Form C-103
 Revised July 18, 2013

WELL API NO. 30-015-34698
5. Indicate Type of Lease STATE ☒ FEE ☐
6. State Oil & Gas Lease No.
7. Lease Name or Unit Agreement Name JOEL STATE
8. Well Number #001
9. OGRID Number 16696
10. Pool name or Wildcat [86480] TURKEY TRACK;MORROW (GAS)

OXY PROPOSES TO PLUG AND ABANDON THE SUBJECT WELL. THE PA PREP PROCEDURE IS ATTACHED AND MIGHT BE EXECUTED. THE CURRENT WELLBORE, PROPOSED WELLBORE, AND PA PROCEDURE ARE ATTACHED.

NOTICE OF INTENT TO PLUG AND ABANDON**10/10/2024****JOEL STATE 1****30-015-34698-0000****PE: Travis Brashear****PLUGGING PROCEDURE:**

CURRENT WBD

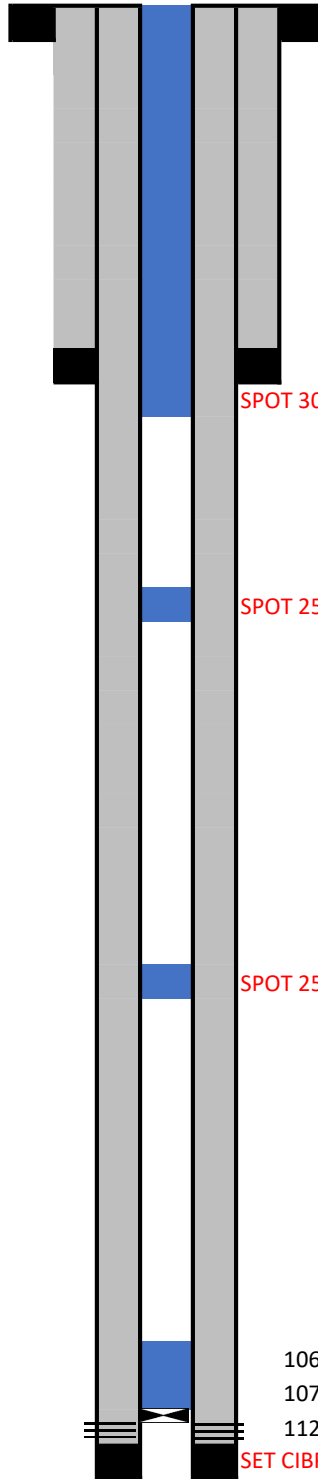
SEE CHANGES TO PREP WORK & PLUGGING PROCEDURE

1. 10# MLF between plugs. Utilize above ground steel tanks.
2. POOH with production equipment.
3. RUN CBL 11,035' to Surface.
4. Spot 15 sx cmt 11300' - WOC & Tag 11200' or higher - T Barnett
5. SET CIBP @10,985'. Test casing 500psi/30min - Bubble Test -SPOT 45 SXS CLASS H CMT 10,985'. WOC AND TAG 10600' or higher
6. Spot 15 sx cmt 10140' - WOC & Tag 10040' or higher - Top Strawn
7. Spot 15 sx cmt 9680' - WOC & Tag 9580' or higher - T Penn
8. Spot 15 sx cmt 8910' - WOC & Tag 8810' or higher - T Wolfcamp
9. SPOT 25 SXS CLASS H CMT 7,650' - 7,450'. WOC AND TAG.
10. SPOT 25 SXS CLASS H CMT 4,500' - 4,250'. WOC AND TAG.
11. Spot 15 sx cmt 3530' - WOC & Tag 3430' or higher
12. SPOT 302 SXS 3,055' - Surface. WOC AND TAG.
13. APPROXIMATE TOTAL OF 397 SXS OF CEMENT

SET CIBP @10,985'. SPOT 45 SXS CLASS H CMT 10,985' - 10,620'. WOC AND TAG.
